USB Type-C ENGINEERING CHANGE NOTICE

Title: Ra Requirements

Applied to: USB Type-C Specification Release 2.4, Oct 2024

Figure 4-X1 Electronically Marked Direct Connect Device with a Captive Cable SOP' powered by VCONN

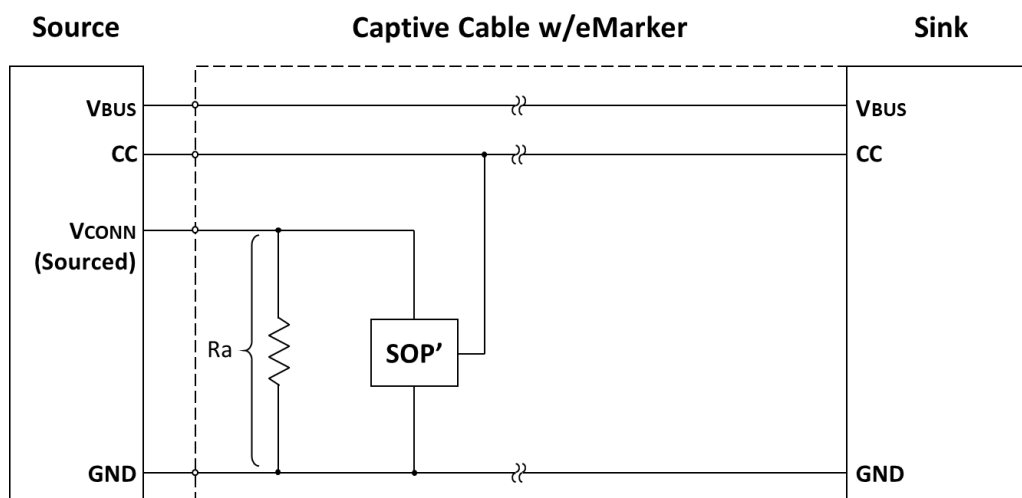
Figure 4-X1 illustrates an electronically marked direct connect device with a captive cable where the SOP' is powered by VCONN.

Figure 4-X2 Electronically Marked Direct Connect Device with a Captive Cable with SOP' Powered by VBUS or local power

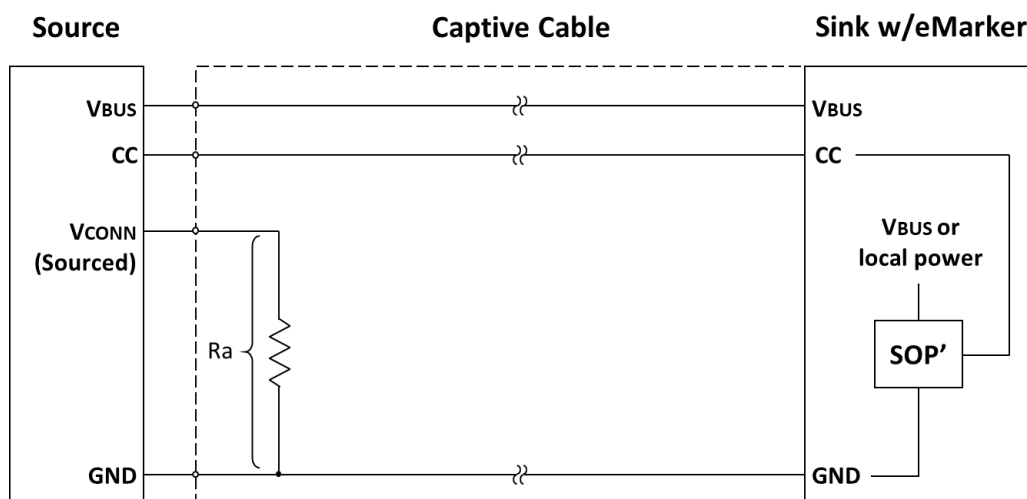
Figure 4-X2 illustrates an electronically marked direct connect device with a captive cable where the SOP' is not powered by VCONN. While the SOP' doesn't rely on VCONN for power, ***Ra shall*** still be implemented but is not required to be weakened or adhere to the Ra Management State Machine defined in Section 4.5.2.5. Note: Even if the SOP' is integrated into the SOP, the timing requirements in Section 4.5.2.4 still apply.

Figure 4-X3 Electronically Marked Direct Connect Device with No Cable with SOP' Powered by VCONN

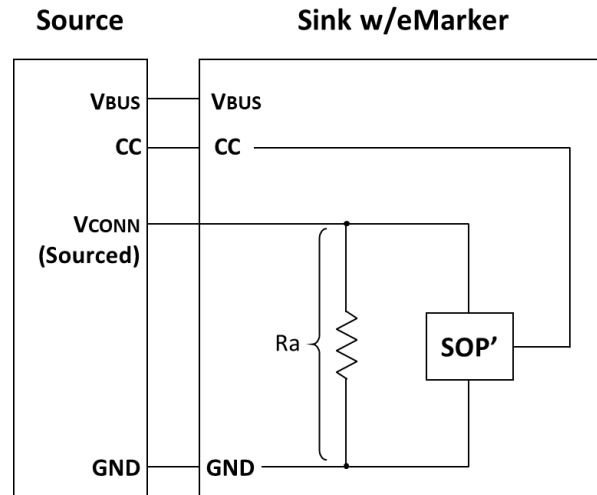
Figure 4-X3 illustrates an electronically marked direct connect device with no cable (e.g., thumb drive) where the SOP' is powered by VCONN.

Figure 4-X4 Electronically Marked Direct Connect Device with No Cable with SOP' Powered by VBUS or local power

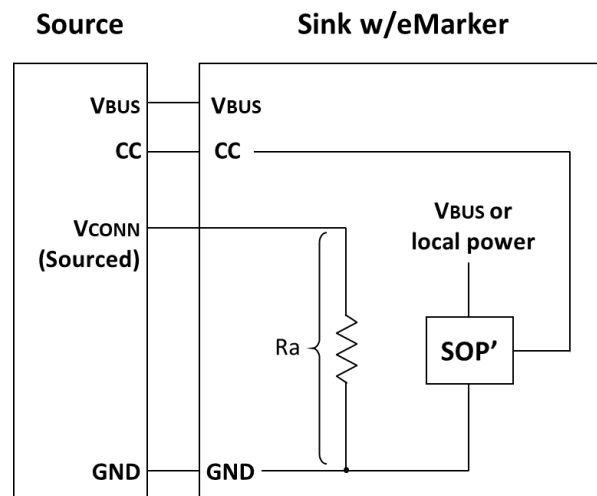
Figure 4-X4 illustrates an electronically marked thumb drive where the SOP' is not powered by VCONN. While the SOP' doesn't rely on VCONN for power, **Ra shall** still be implemented but is not required to be weakened or adhere to the Ra Management State Machine defined in Section 4.5.2.5. Note: Even if the SOP' is integrated into the SOP, the timing requirements in Section 4.5.2.4 still apply.
